Groundwater Transfer Review Summary Form

Transfer/PA # T- 14251

Application: T-14251

Applicant Name: Willamette Tree Wholesale Inc.

Theis Analysis: authorized POA (MARI 4898) to MARI 4199

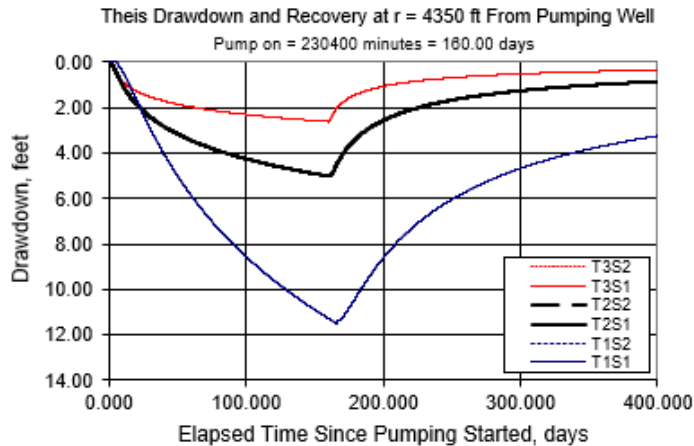
3. a) Will this proposed change, at its maximum allowed rate of use, likely result in an increase in interference with **another ground water right**?
☒ Yes ☐ No Comments: **Certificate 40295 (yes):** relative to the authorized POA location (MARI 4898), the locations for two of the three proposed POA (MARI 4897, MARI 70766) 4888) are relatively nearer by about 2300 feet to MARI 4199, a domestic use well. Therefore the proposed change will likely result in an increase in interference with MARI 4199.
Certificate 50713 (no): relative to the authorized POA locations (MARI 4880, MARI 4897), the locations for the two proposed APOA (MARI 4888, MARI 70766) are not appreciably relatively nearer to any known groundwater right.

b) If yes, would this proposed change, at its maximum allowed rate of use, likely result in another groundwater right not receiving the water to which it is legally entitled?
☐ Yes ☒ No If yes, explain: **Certificate 40295:** none of the area's wells fully penetrate the alluvial aquifer system in this area, estimated to be about 500-700 feet thick (Gannett and Caldwell, 1998), and thus are not subject to injury determinations (the nearest potentially-affected well MARI 4199 is only 147 feet deep, and other nearby wells MARI 4227 and MARI 4222 are even shallower at 85 and 86 feet deep, respectively).
Nonetheless, a Theis distance-drawdown analysis was completed to estimate the net additional drawdown at the MARI 4199 location potentially caused by the proposed use (i.e., increased pumping specifically at the MARI 70766 and MARI 4897 locations). The results of the Theis analysis, using very conservative operational parameters (24/7 pumping for 160 days), indicate that perhaps ~2 to 10 feet of additional drawdown might be experienced in MARI 4199; despite its relatively-shallow depth, this amount of additional drawdown should be able to be accommodated in MARI 4199 and other similarly-completed (and not fully penetrating) wells. Furthermore, performance of wells in this area indicate a very prolific Willamette Aquifer system that should help mitigate any potential well interference effects not identified in this review (e.g., notably high specific capacity value and reported well yield for nearby MARI 58798).
